SERVICE BULLETIN

SB-AG-65

**Installation of Click Bond Electrical
Grounding Spacer Stud on the Header Tank**

AIRCRAFT AFFECTED:	
<u>MODEL</u>	<u>SERIAL NUMBERS</u>
S2R-H80	101 through 200

Figure 65-1

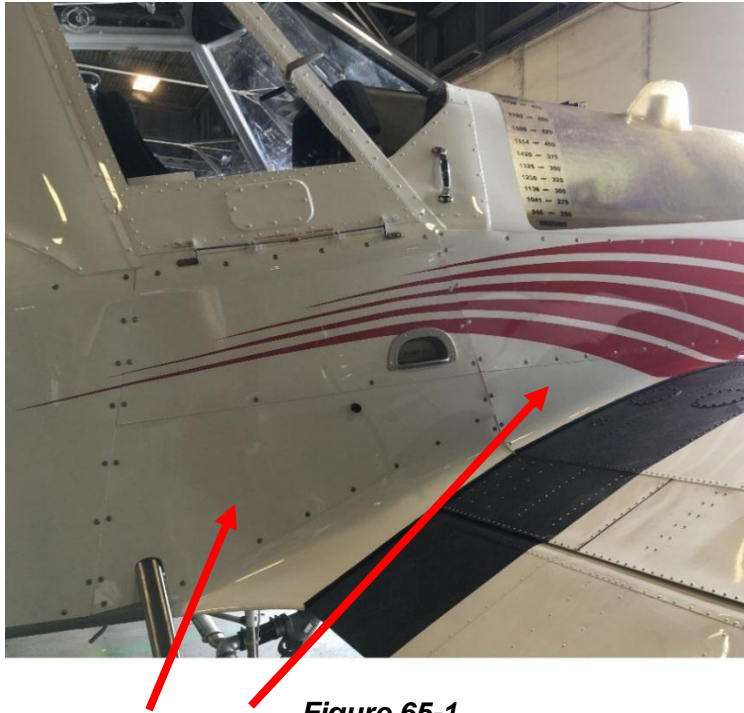
- 7.1 Place the aircraft in a suitable maintenance facility. Recommended to Defuel Airplane.
- 7.2 Remove those aircraft skins and fairings necessary to gain access to the header tank on the aircraft right-hand side, located under the cockpit. See Figure 65-1.

Figure 65-3

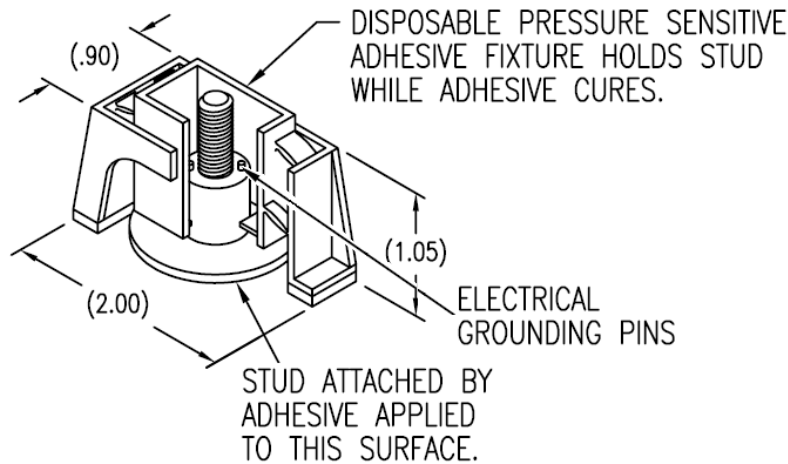
7.5 Figure 65-3 shows the ground stud configuration prior to installation.

Figure 65-4

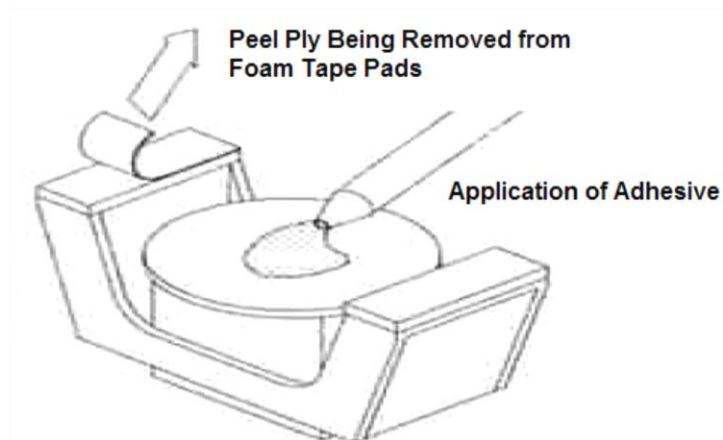
7.7.3 Apply the mixed adhesive to the fastener baseplate. Do not overapply. The amount needs to be enough to cover the entire area to properly bond. A film a few thousandths thick is adequate.

Figure 65-5

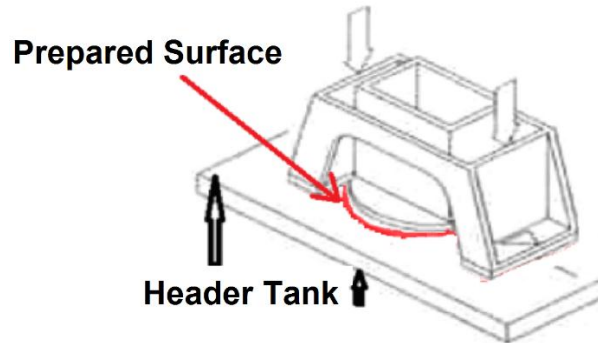
7.7.4 Locate the ground stud assembly over the area where paint, primer, and corrosion protection layer was removed.

7.7.5 Press down on the outer body to adhere the foam tape to the surface.

Figure 65-6

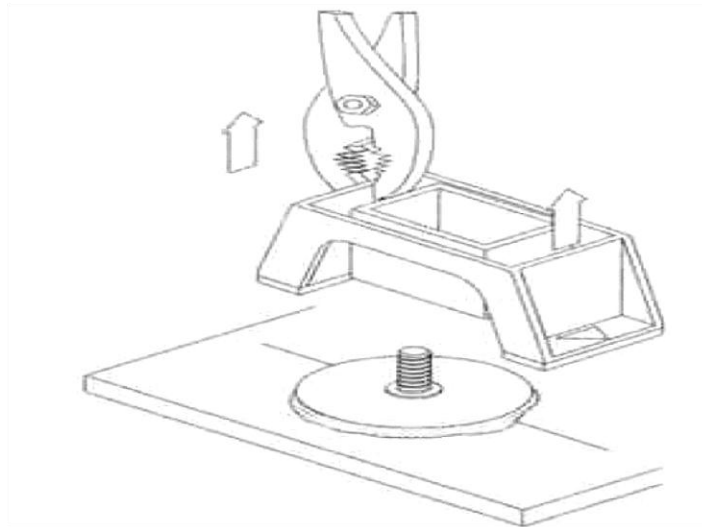
- 7.7.6** Press down on the inner body of the ground stud assembly to actuate. The application of force should cause a “click” as the plastic install device locates the stud.
- 7.7.7** Do not press on the protruding fastener.
- 7.7.8** Verify all exposed edges of bonded stud show a continuous adhesive bead squeezing out along the joined surfaces.
- 7.7.9** Allow the adhesive to cure for 2 hours at 75° F.
- 7.7.10** Using pliers, pull the outer fixture from the substrate.

Figure 65-7

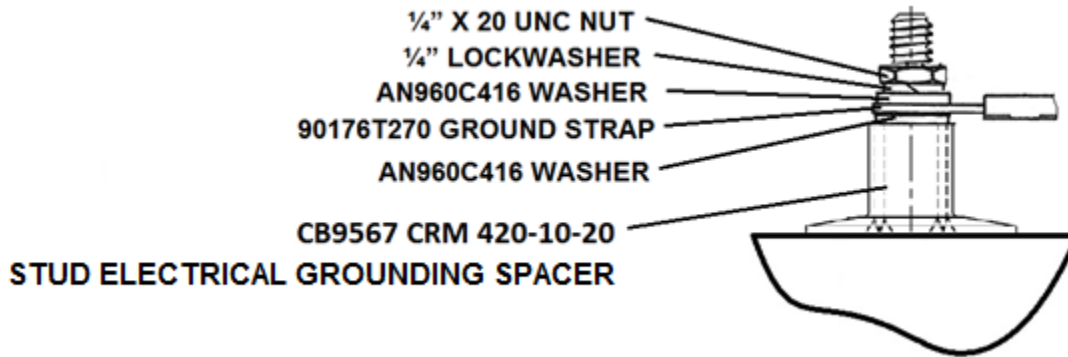
- 7.7.11** Verify that the stud is firmly attached by applying 5 lbs. of force to the threaded portion. Discard fixture.
- 7.7.12** Install 90176T270 ground bonding strap in this order: flat washer, terminal lug from ground strap assembly to stud, flat washer, lock washer and the nut.

Figure 65-8

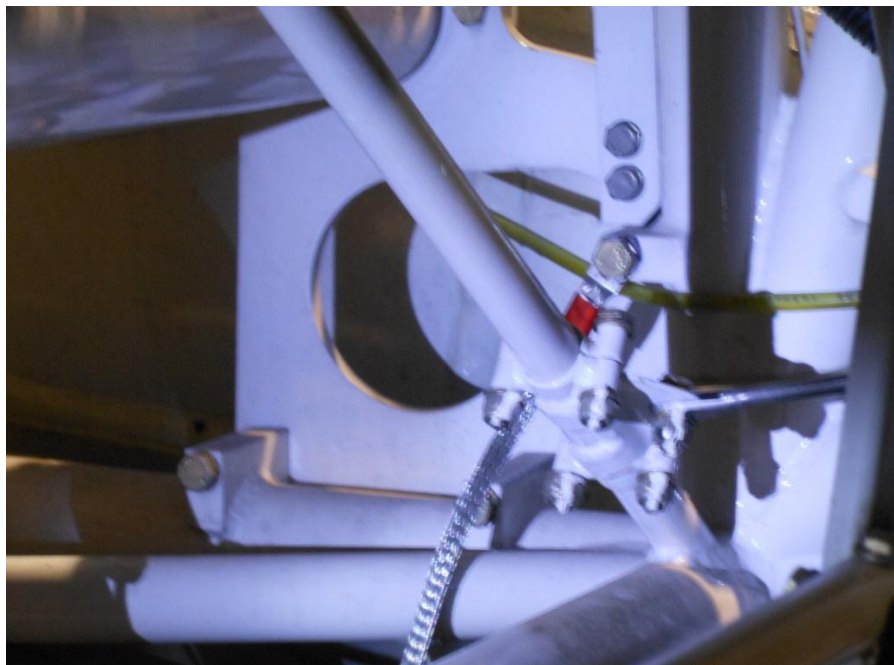
- 7.7.13** Tighten nut until ground pins of the strap penetrate adhesive. Do not overtighten as over-torque could damage the installation.
- 7.7.14** After removing paint from the Flap Shaft Bolt seat, attach other end of the Ground Strap Assembly to Flap Shaft Bolt and secure with existing hardware. The Ground Strap Assembly Terminal can replace the existing washer under the head of the Flap Shaft Bolt.
- 7.7.15** Use an ohm meter to verify a good ground. Measuring from the tank surface to the negative battery lead, Ohm meter should not show any resistance. The aft pin of the ground power plug is also a good alternate ground location.
